**BEAR CREEK STREAM
ALTERATION PERMIT**

RE: Stream Channel Alteration Permit Number 92-93-02SA to install a 60" culvert in Bear Creek.
EXPIRATION DATE: September 2, 1993

RE: Stream Channel Alteration Permit Number 00-93-01SA for placement of culverts on Bear Creek and on the right fork of Bear Creek in Emery County.
EXPIRATION DATE: April 10, 2002

RE: Stream Channel Alteration Permit Number 01-93-07SA for mining construction and culvert placement on the right fork of Bear Creek in Emery County.
EXPIRATION DATE: August 28, 2002

PLATE C

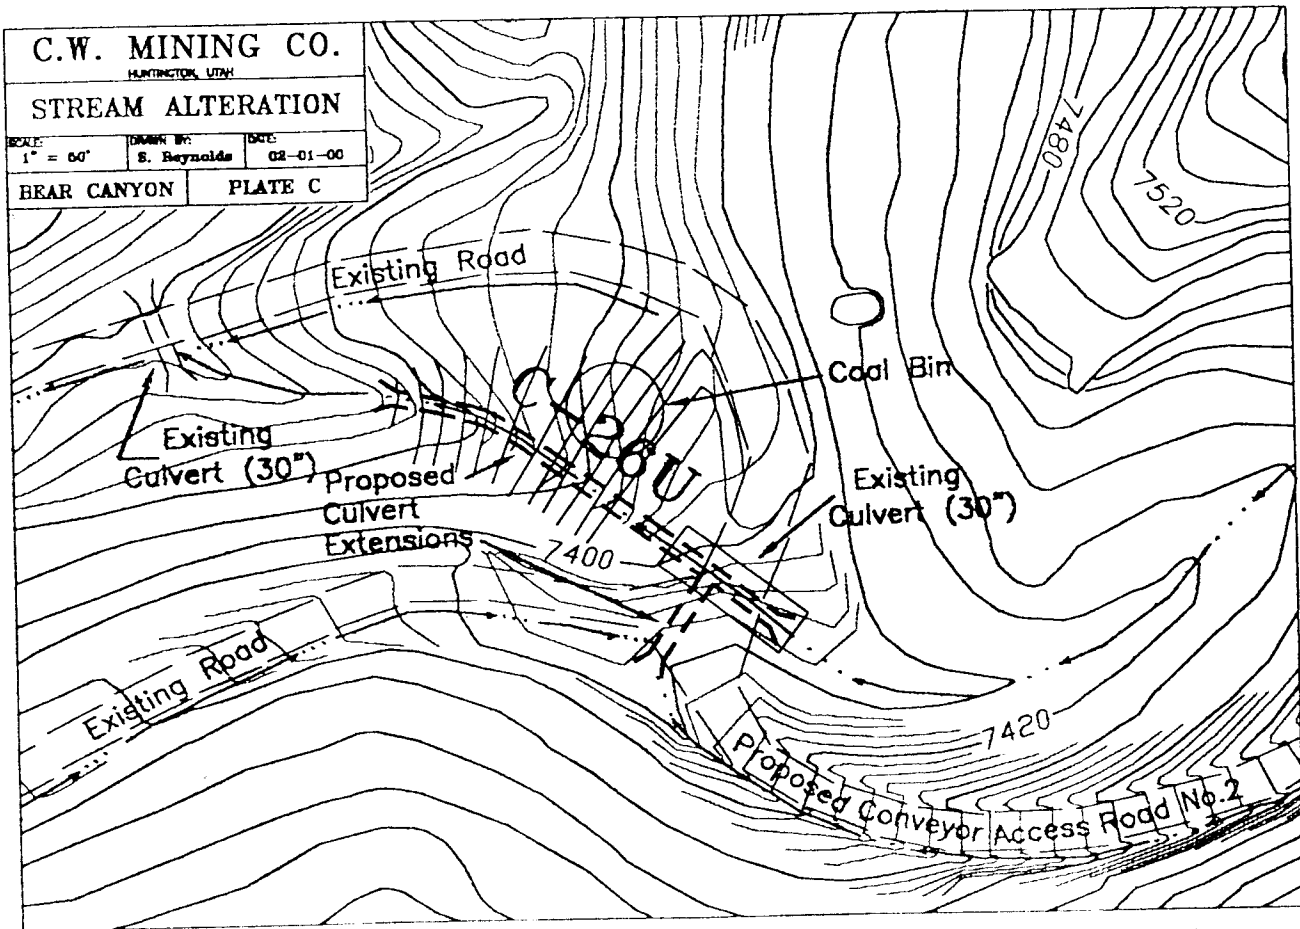
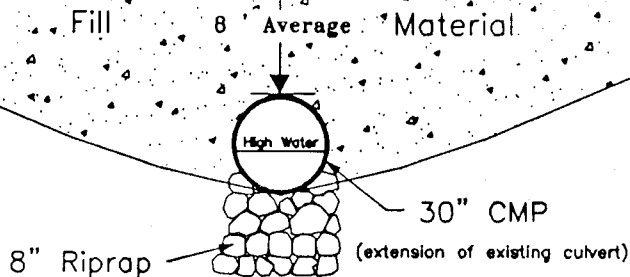
10. Culverts must be designed to withstand depth of fill, buildings, and construction activities. Methods such as use of concrete encased pipes may need to be utilized, especially for culverts shown on plates F and C.

PLATE A

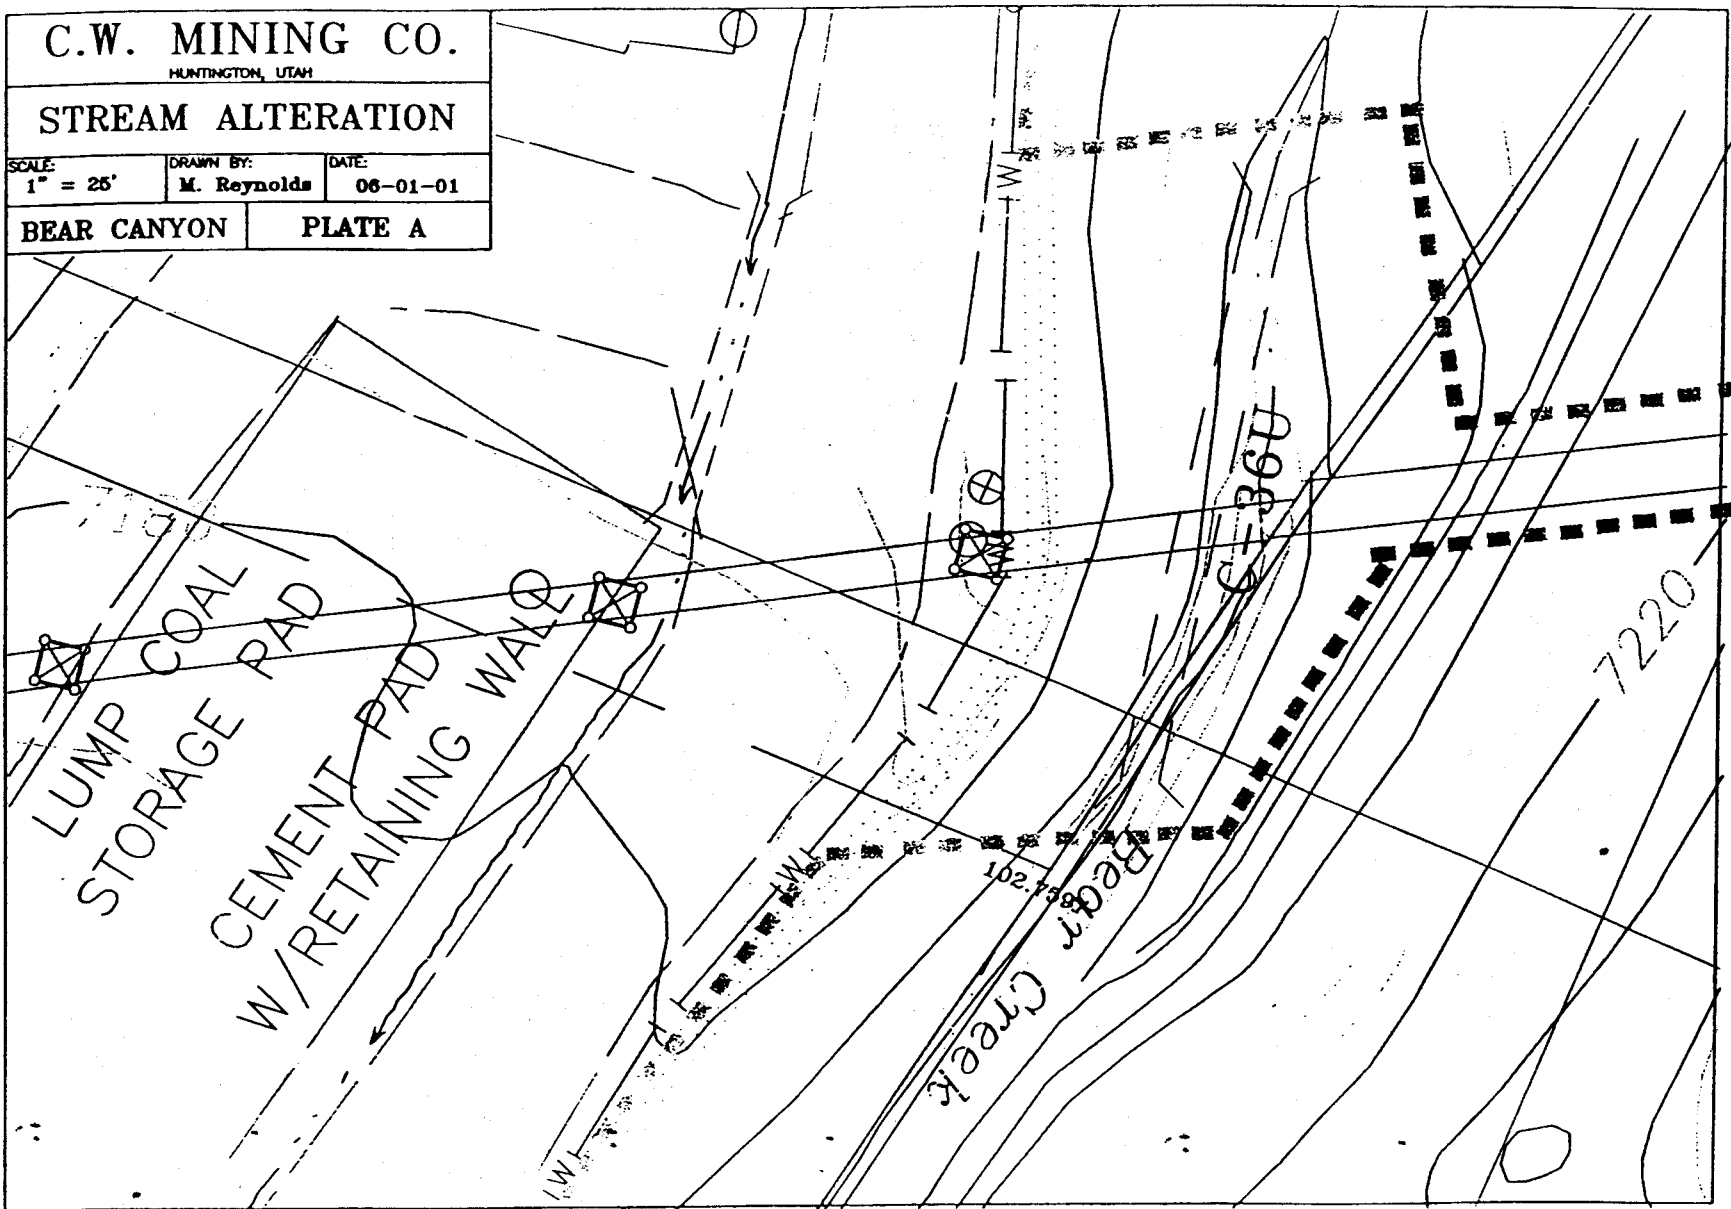
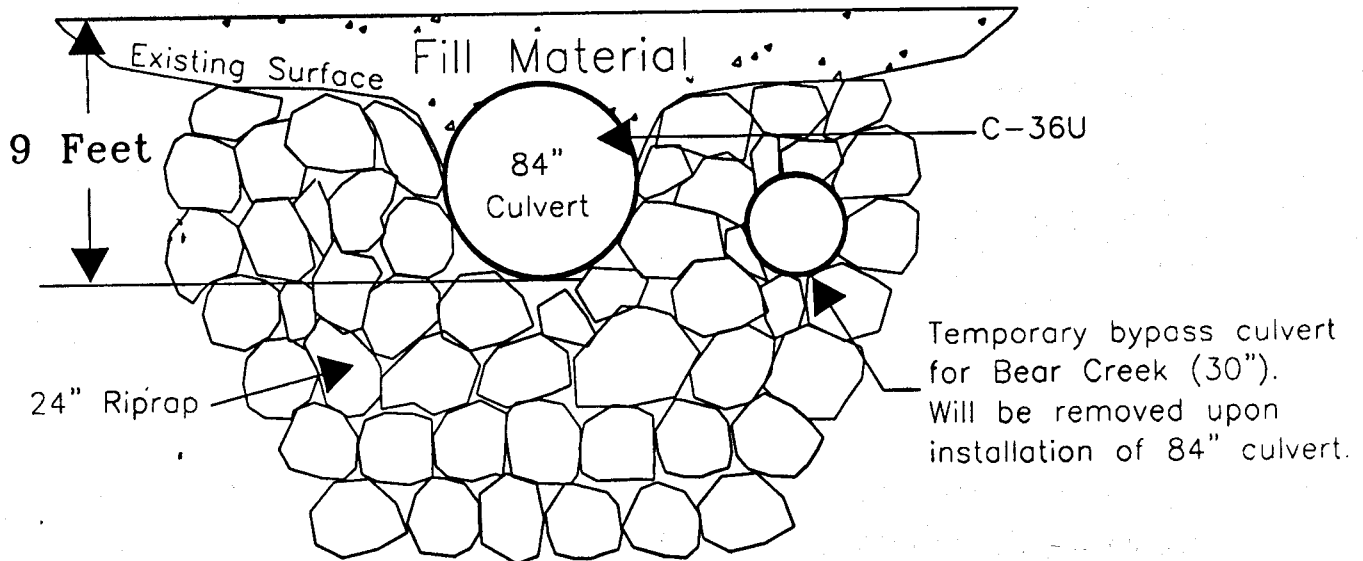
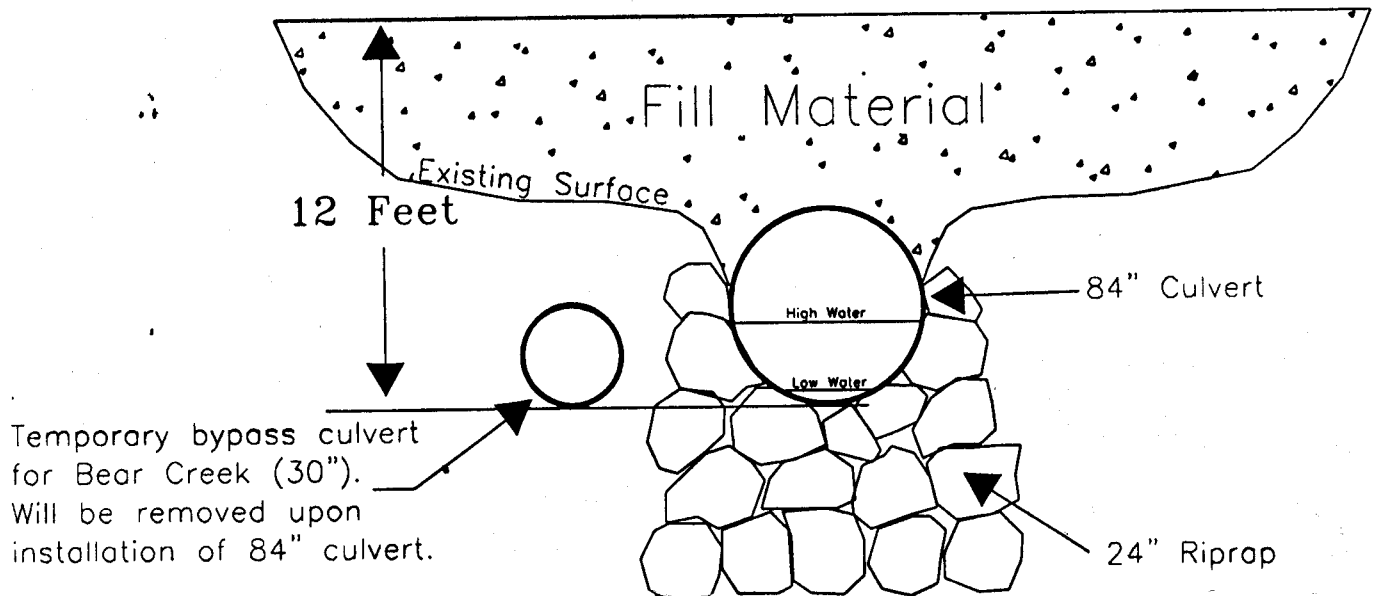
After further evaluation C.W. Mining Co. elected not to alter the stream in Area A. The stream was never culverted in this location and culvert C-36U is located in a different area.

PLATE B

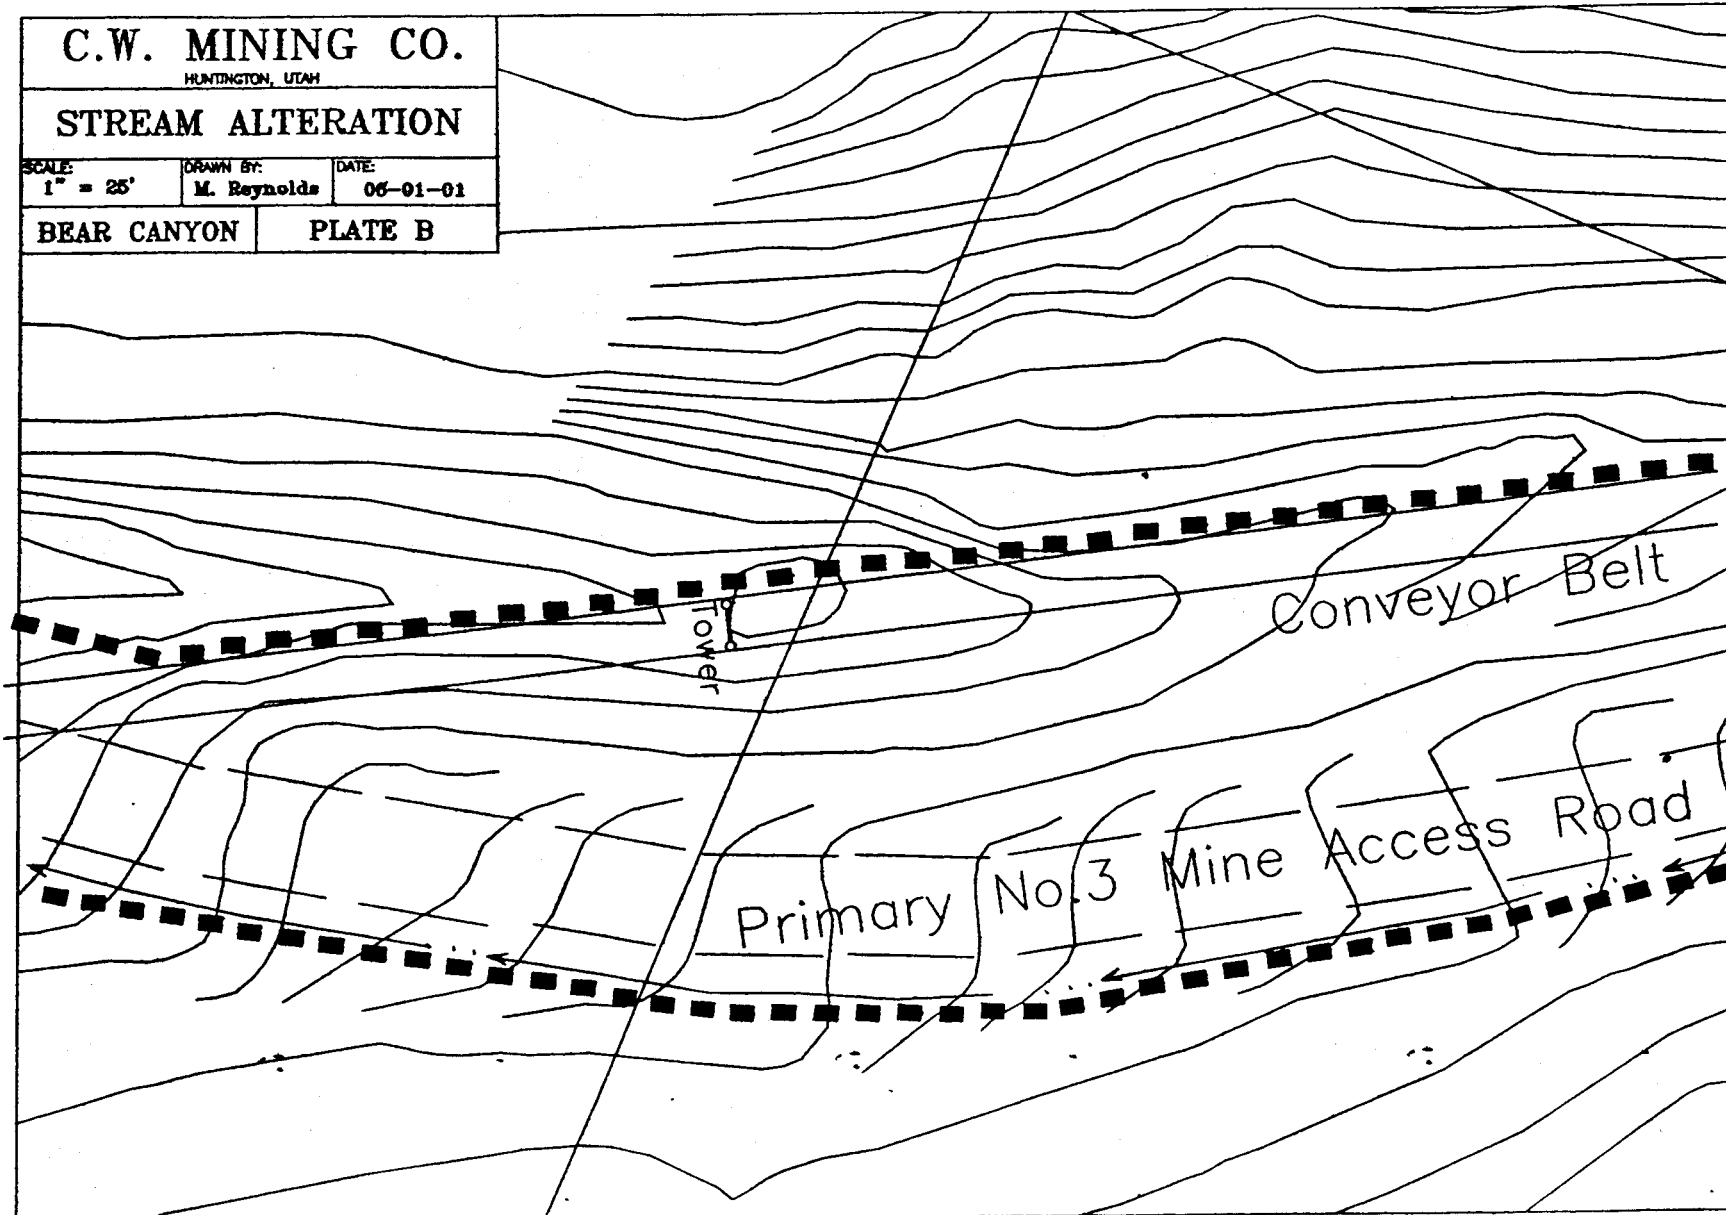
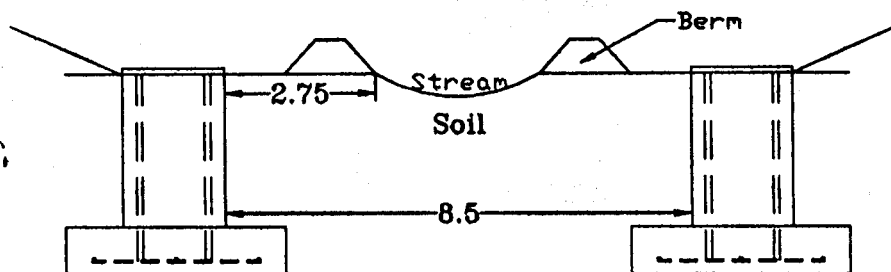
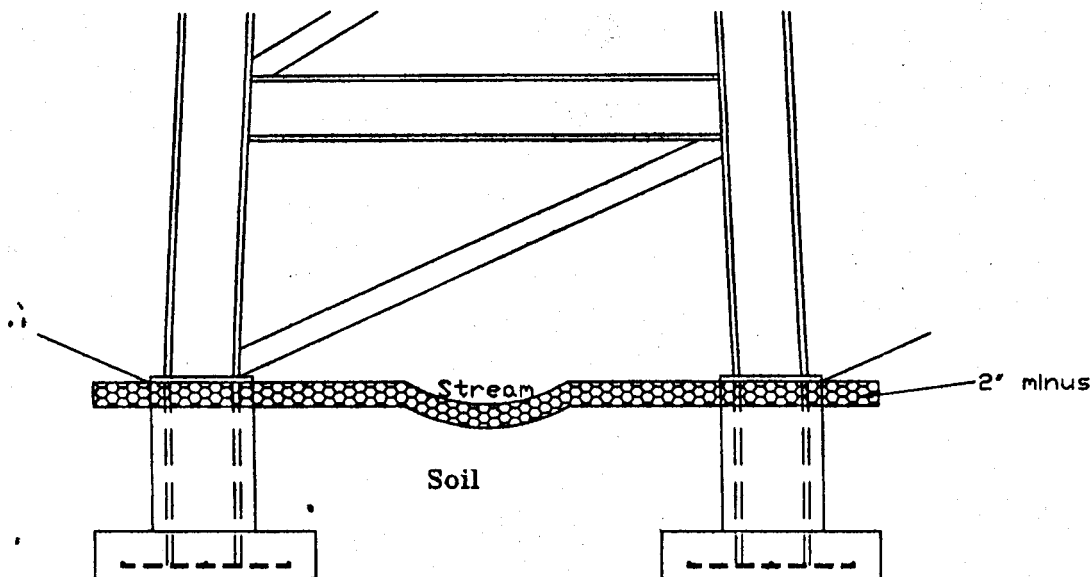
6. Sites B and C are on dry channels, but best management practices must be employed to maintain occasional flood flow events.
7. All sites must be vegetated with appropriate grasses and woody vegetation. Proper stream form and function must be restored and vegetation success reported prior to the compliance inspection. Also, plans for reclamation of the stream, once mining is completed, must be addressed in the Utah Division of Oil, Gas, and Mining documentation (CO-OP Mine Plans).
